WINCHESTER SUBDIVISION

APPLICATION NUMBER 20 DATE May 4, 2006

APPLICANT Winchester Subdivision

REQUEST Subdivision

DETAIL SITE PLAN

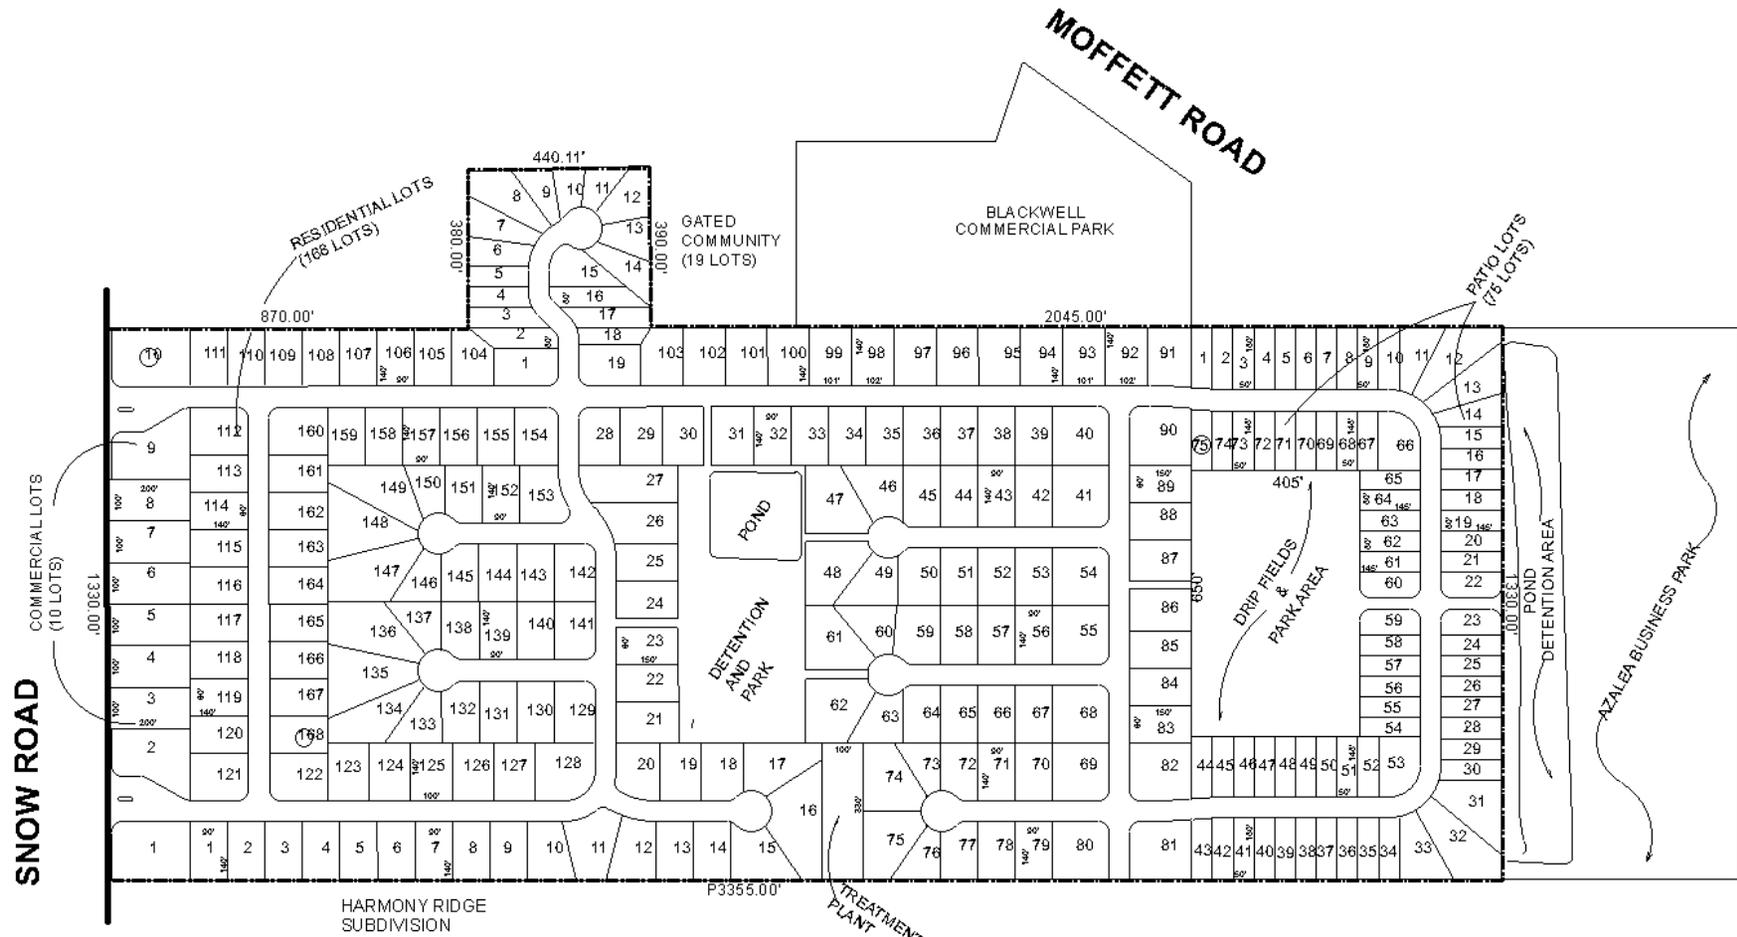
Snow Road, which has an existing right-of-way of 80 feet, is a major street as shown on the Major Street Plan, and as such requires a minimum right-of-way of 100 feet and may require some method of access management. The plat submitted indicates that the lots fronting Snow Road are to be commercial lots, and indicates what appears to be dedication of additional right-of-way for portions of the Snow Road frontage. Given the commercial nature of the lots fronting Snow Road, and the overall number of lots proposed, dedication sufficient to provide a minimum right-of-way of 50' from centerline for the entire Snow Road frontage should be required. Additionally, limiting the number of curb cuts to Snow Road would be an acceptable method of access management. Lots 1, 2, 9 & 10 are corner lots, and should be denied access to Snow Road, limiting them to access via the new street; Lots 3-8 should be limited to a total of three curb cuts to Snow Road, with the exact size, location and design to be approved by County Engineering.

As Lots 1-10 are designated for commercial development, a note should be placed on the final plat stating that a buffer, in compliance with Section V.A.7. shall be provided where the commercial properties adjoin residential property.

As a side note, the areas designated as the treatment plant, the drip fields, park areas, roadway medians, and detention areas, should also be designated and labeled as Common Areas, with a note placed on the final plat stating that all Common Areas are to be maintained by the property owners.

It should also be noted that areas shown for detention, drip fields and parks should have lot lines closed to show that they are not part of the street right-of-way system.

The plat meets the minimum requirements of the Subdivision Regulations and is recommended for Tentative Approval, subject to the following conditions: 1) submission of documentation of approvals for the centralized effluent disposal system from the Mobile County Board of Health and ADEM prior to recording of the final plat; 2) placement of a note on the final plat drip field area must not be used for vehicular traffic or parking; 3) revision of the lots lines to separate detention, park and drip field areas from the street right-of-way; 4) inclusion of the entirety of the parcel utilized as an access road for the Blackwell Nursery site, if said parcel is part of the proposed subdivision; 5) designation and labeling of the treatment plant, the drip fields, park areas, roadway medians, and detention areas as Common Areas, and placement of a note on the final plat stating all common areas shall be maintained by the property owners; 6) dedication of sufficient right-of-way to provide a minimum of 50 feet from centerline for the entire Snow Road frontage; 7) placement of a note on the final plat stating that lots 1, 2, 9 & 10 are denied direct access to Snow Road; 8) placement of a note on the final plat stating that lots 3-8 are limited to a total of three curb cuts to Snow Road, with the size, location and design to be approved by Mobile County Engineering; 9) depiction of the 25-foot minimum building setback line; 10) placement of a note on the final plat stating that a buffer, in compliance with Section V.A.7. shall be provided where the commercial properties adjoin residential property.
